Autoclass reference time v102

Info (not part of baseline)

Figure 145–14—PSE Autoclass state diagram

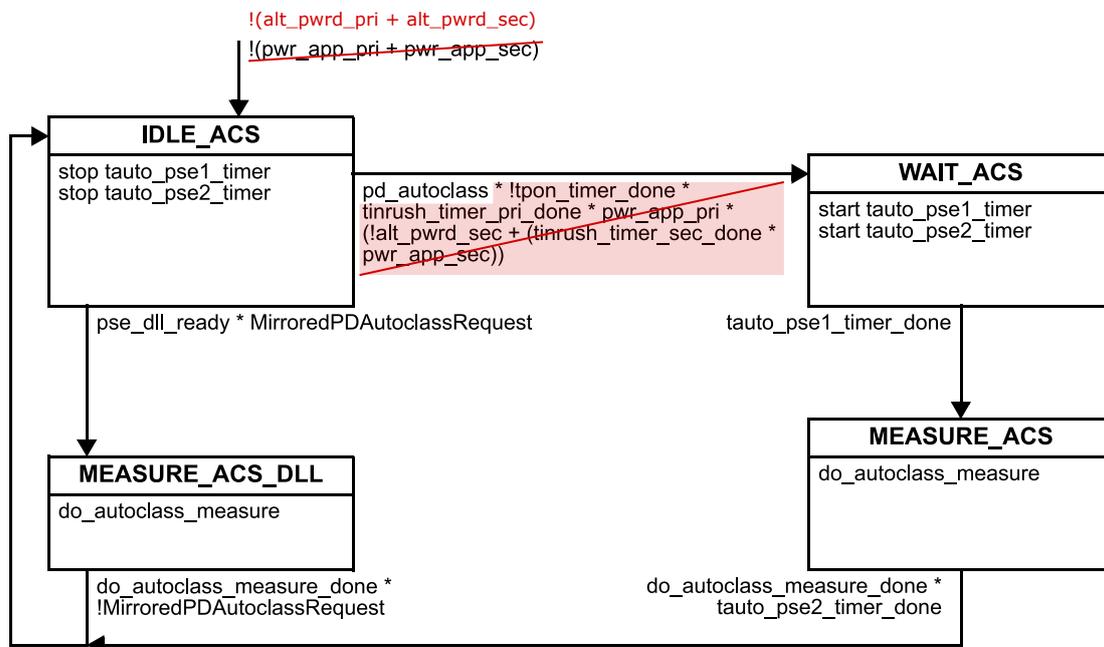
The Autoclass measurement period for the PSE (defined by $T_{\text{AUTO_PSE1}}$ and $T_{\text{AUTO_PSE2}}$) and the Autoclass maximum power draw period for the PD (defined by $T_{\text{AUTO_PD1}}$ and $T_{\text{AUTO_PD2}}$) is referenced from two different points in time. The reference time for the PSE is “the transition of POWER_UP to POWER_ON”, where that for the PD is “measured when V_{PD} rises above $V_{\text{Port_PD-2P min}}$ ”. The PSE’s time reference is not readily observable at the PI. This is unnecessarily complicated.

This baseline proposes to change both reference times to when V_{PSE} or V_{PD} crosses 30V (the initial crossing after classification). Regardless of what inrush scheme is used^a, this point in time occurs near simultaneous for both devices and is observable at the PI. Timings can remain as-is.

Change Figure 145–14 as follows:

$T_{\text{AUTO_PSE1}}$ and $T_{\text{AUTO_PSE2}}$ timing is referenced from ~~the transition of the POWER_UP state to the POWER_ON state when V_{PSE} exceeds 30 V.~~

Measured from when V_{PSE} exceeds 30 V.

Figure 145–26—Single-signature PD Autoclass state diagram

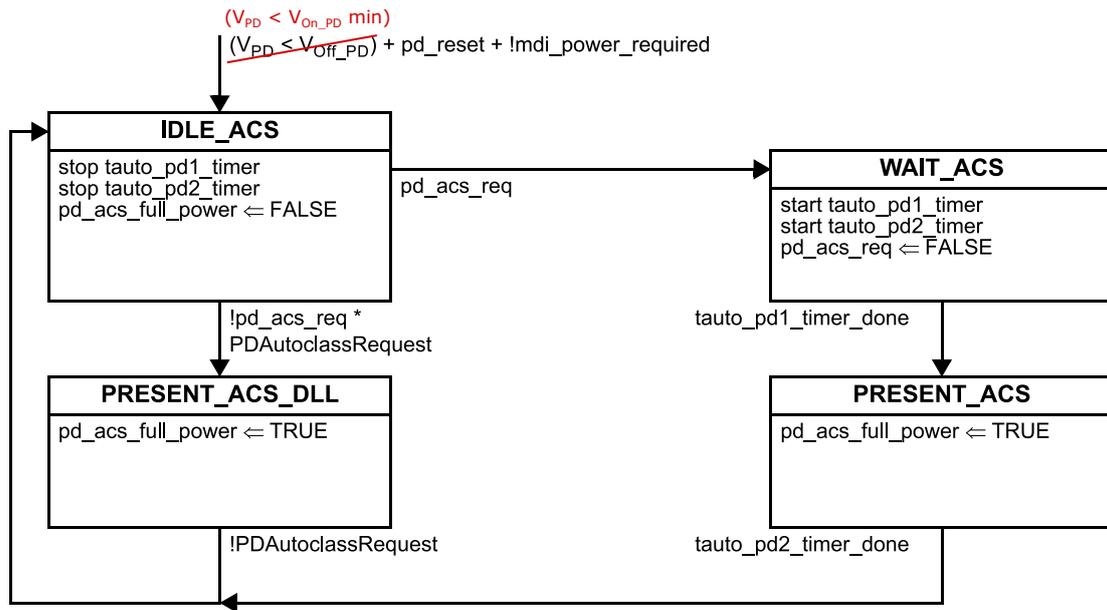
A final issue is that currently the PD state diagram does not agree with the PD Autoclass text. While the text uses $V_{\text{Port_PD-2P min}}$ as reference, the state diagram uses $V_{\text{PD}} > V_{\text{Off_PD}}$ as the reference point.

Change Figure 145–26 as follows:

After power up, a PD that implements Autoclass shall draw its highest required power, $P_{\text{Autoclass_PD}}$, subject to the requirements on $P_{\text{Class_PD}}$ in 145.3.8.2, throughout the period bounded by $T_{\text{AUTO_PD1}}$ and $T_{\text{AUTO_PD2}}$, measured from when V_{PD} rises above ~~$V_{\text{Port_PD-2P min}}$~~ $V_{\text{On_PD min}}$.

Measured from when V_{PD} rises above $V_{\text{On_PD min}}$.
